Wisconsin Electric POWER COMPANY
231 W. MICHIGAN, P.O. BOX 2046, MILWAUKEE, WI 53201

June 28, 1984

DOCKET NOS. 50-266 AND 50-301
SUBMITTAL OF QUALITY ASSURANCE PROGRAM DESCRIPTION
POINT BEACH NUCLEAR PLANT, UNITS 1 AND 2

Figure 1.8-1 WISCONSIN ELECTRIC POWER COMPANY ORGANIZATION WITH QUALITY ASSURANCE INTERFACE TO POINT BEACH NUCLEAR PLANT

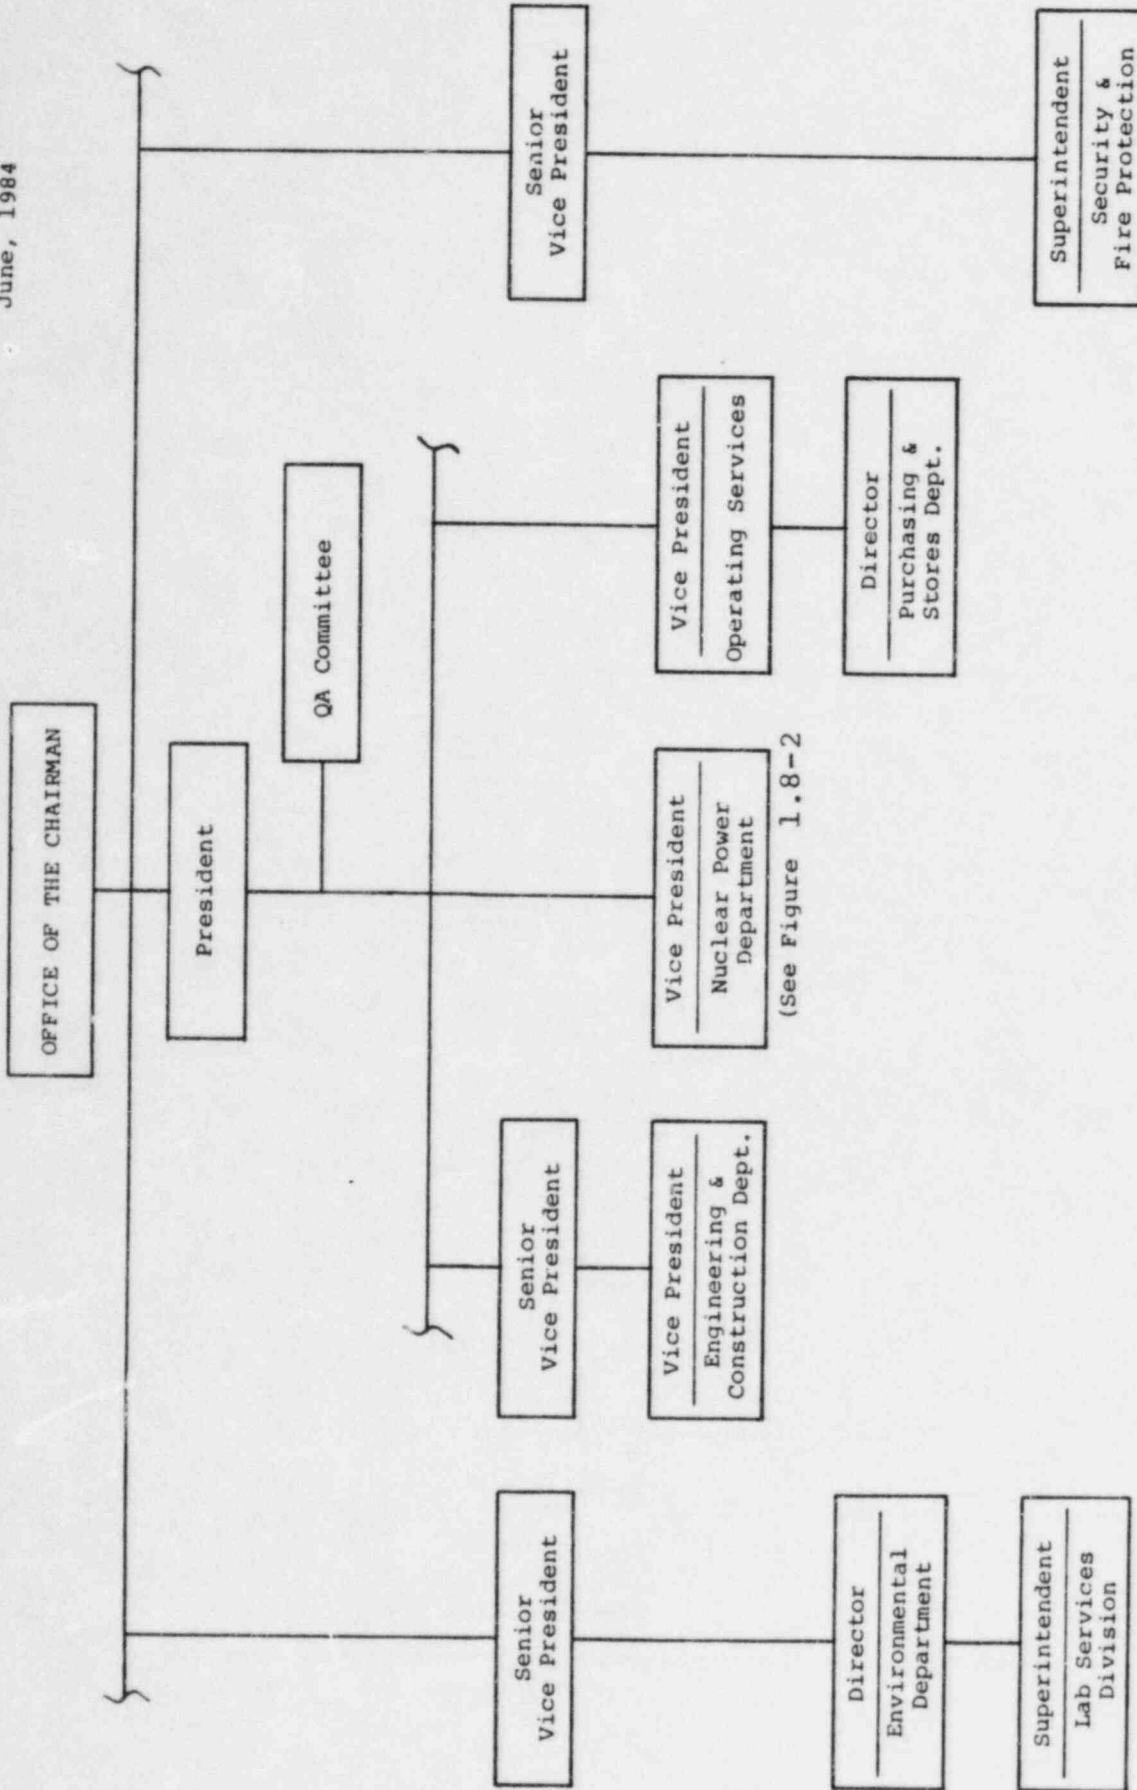
1. General - On two occasions since our last submittal, changes have been made in the Company and Nuclear Power Department organizations as depicted in Figures 1.8-1 through 1.8-4:
 - a. On January 1, 1984 the Nuclear Engineering Section was split into two sections: Nuclear Systems Engineering and Analysis Section and Nuclear Plant Engineering & Regulation Section. Each section is headed by a General Superintendent. Also at this time the Superintendent of QA became the General Superintendent of the QA Section (Figures 1.8-2 and 1.8-4).
 - b. Effective May 9, 1984, the Vice President - Nuclear Power Department now reports to the President (Figure 1.8-1).

The organizational and title changes are reflected throughout Section 1.8 as part of this revision. None of these changes effect our quality assurance commitments since the authority and independence of the Vice President-NPD and the Quality Assurance organization is not reduced.
